# UNITED STATES PATENT AND TRADEMARK OFFICE

APPLICATION NO.	FILING DATE	FIRST NAMED INVENTOR	ATTORNEY DOCKET NO.	CONFIRMATION NO.
10/537,372	06/03/2005	Bernard Diem	272637US2PCT	2639
22850 7590 04/12/2007 OBLON, SPIVAK, MCCLELLAND, MAIER & NEUSTADT, P.C. 1940 DUKE STREET ALEXANDRIA, VA 22314			EXAMINER BAUMAN, SCOTT E	
			ART UNIT	PAPER NUMBER
			2815

## Office Action Summary

## **DETAILED ACTION**

FIG. 12

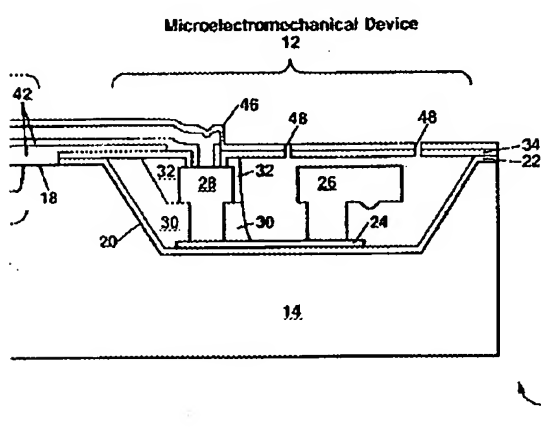
Barron et al '788 discloses the package cap (Fig 13, item 34) further comprises at least one orifice (Fig 12, item 48) configured to be being sealed by a plug (Fig 13, item 50) to control atmosphere of the cavity (Col 10, lines 45-47).

FIG. 13

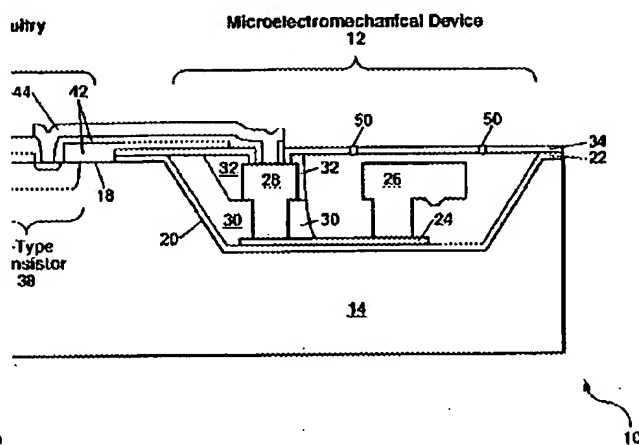
Barron et al '788 discloses a first layer (Fig 13, item 24) insulated from a substrate (Fig 13, item 14) by an insulator layer (Fig 13, item 22) at least one sensitive element (Fig 13, item 26) connected to at least one contact pad (Fig 13, item 28) by an electrical connection (Fig 13, item 24) and protected by a package cap (Fig 13, item 34), wherein the at least one sensitive element (Fig 13, item 26), the electrical connection (Fig 13, item 24), and the at least one contact pad (Fig 13, item 28) form an assembly (Fig 13, item 12) delimited in the first layer (Fig 13, item 14) by at least one trench (Fig 13, item 30), the assembly (Fig 13, item 12) being covered by the package cap (Fig 13,

item 34), wherein the package cap (Fig 13, item 34) comprises at least one opening (Fig 13, item 44) above the at least one contact pad (Fig 13, item 28) and being integral with the at least one contact pad (Fig 13, item 28) on edges of the at least one opening (Fig 13, item 44) and a zone (Fig 13, item 18) located beyond the at least one trench (Fig 13, item 30) in relation to the assembly (Fig 13, item 12).

Barron et al '788 discloses the package cap (Fig 13, item 34) is sealed in a leak tight manner to define a leak tight cavity (Col 10, lines 45-47) in which the at least one sensitive element (Fig 13, item 26) is located.

Barron et al '788 discloses the electrical connection (Fig 13, item 24), the at least one contact pad (Fig 13, item 28), and the at least one sensitive element (Fig 13, item 26) are formed in a same material (Col 6, lines 41-50).

Barron et al '788 discloses the package cap (Fig 13, item 34) is formed in a dielectric material (Col 7, lines 54-55).

Barron et al '788 discloses the at least one contact pad (Fig 13, item 28) is covered with a conductive band (Fig 13, item 44) at a level of the at least one opening (Fig 13, item 44).

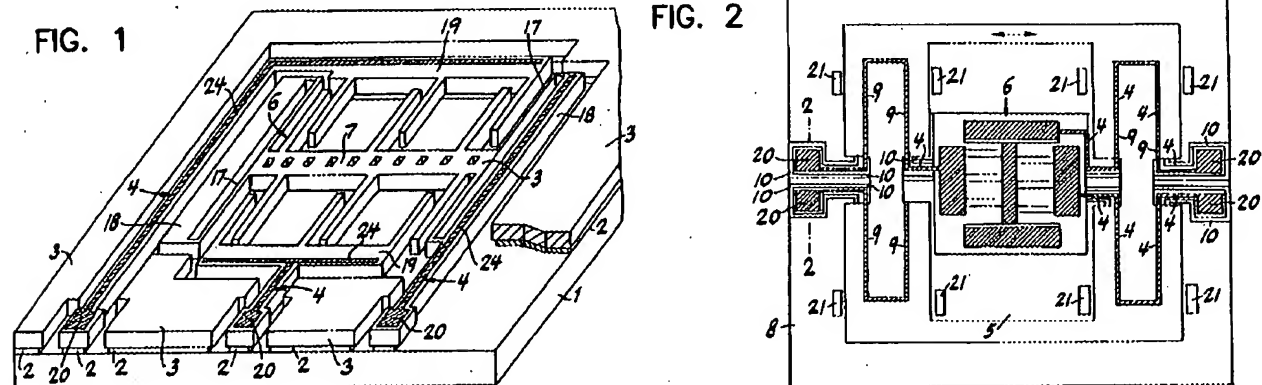
However, Muenzel et al '353 discloses in a first layer (Col 3-4) at least one sensitive element (Fig 1, item 7) connected to at least one contact pad (Fig 1, item 20) by an electrical connection (Fig 1, item 4). wherein the at least one sensitive element

(Fig 1, item 7), the electrical connection (Fig 1, item 4), and the at least one contact pad (Fig 1, item 20) form an assembly (Fig 1) delimited in the first layer (Fig 13, item 3) by at least one trench (Fig 2, item 10)

FIG. 4m

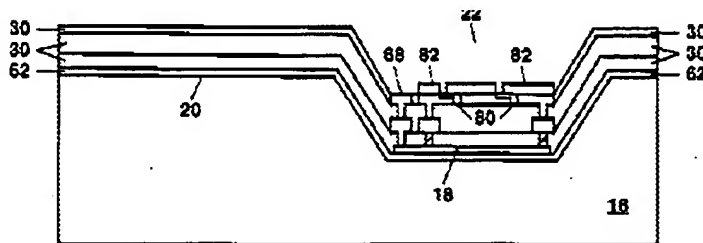
However, Eaton et al '336 discloses the package cap (Fig 4m, item 82) is formed in a semi-conductor or conductor material (Col 14, lines 1-4).

FIG. 4p

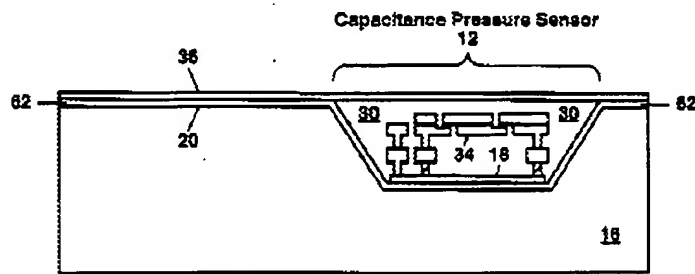
However, Eaton et al '336 discloses the assembly (Fig 4p, item 12) and the package cap (Fig 4m, item 82) are formed in a same conductor or semi-conductor material (Col 13, lines 5-29; Col 14, lines 1-4).

FIG. 4r

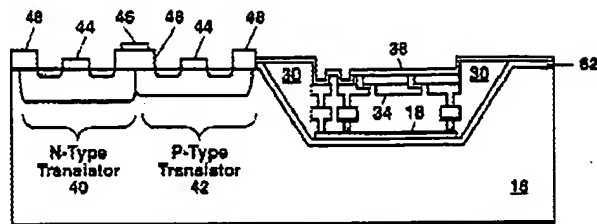
However, Eaton et al '336 discloses a dielectric layer (Fig 4r, item 38) insulates the package cap (Fig 4m, item 82) from the at least one contact pad (Fig 4m, item 68).

However, Eaton et al '336 discloses a dielectric layer (Fig 4r, item 38) insulates the package cap (Fig 4r, item 82) from the zone (fig 4r, item 48).

FIG. 41

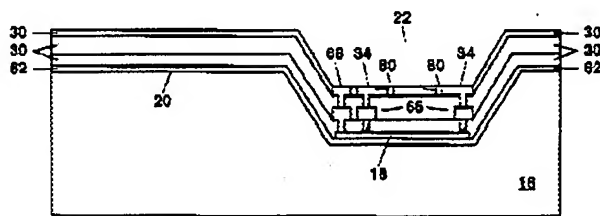
However, Eaton et al '336 discloses the package cap (Fig 4m, item 82) further comprises at least one pillar (Fig 4l, item 66) resting on a zone of the at least one sensitive element (Fig 4l, item 18).

FIG. 4e

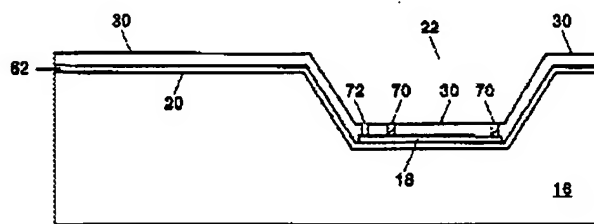
However, Eaton et al '336 discloses the zone of the at least one sensitive element (Fig 4e, item 18) is integral (Fig 4e, item 62) with the substrate (Fig 4e, item 16).
